WARRANTY BULLETIN

Campaign no.: 2018-0004

November 3, 2017 Subject: **850 E-TEC® - Driven Pulley Bearing Support Bolts Out of Specifications** No. **2018-4**

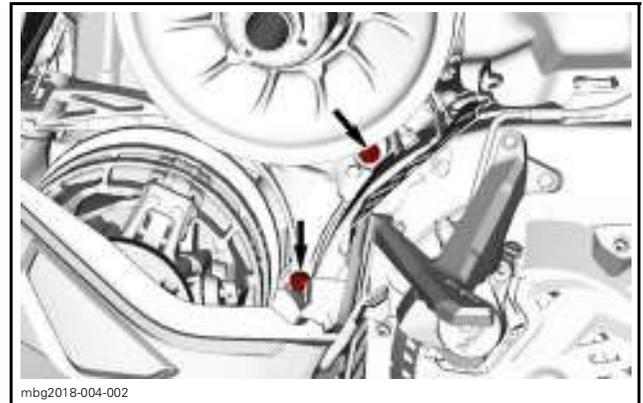
Due to a problem during the manufacture process, the bolts securing the driven pulley bearing support to the engine module could break.

Validate the strength of the bolts by torquing them to the specification indicated in the *STRENGTH VERIFICATION* section.

TORQUE VERIFICATION	
Driven pulley bearing support bolt	33 N•m ± 1 N•m (24 lbf•ft ± 1 lbf•ft)
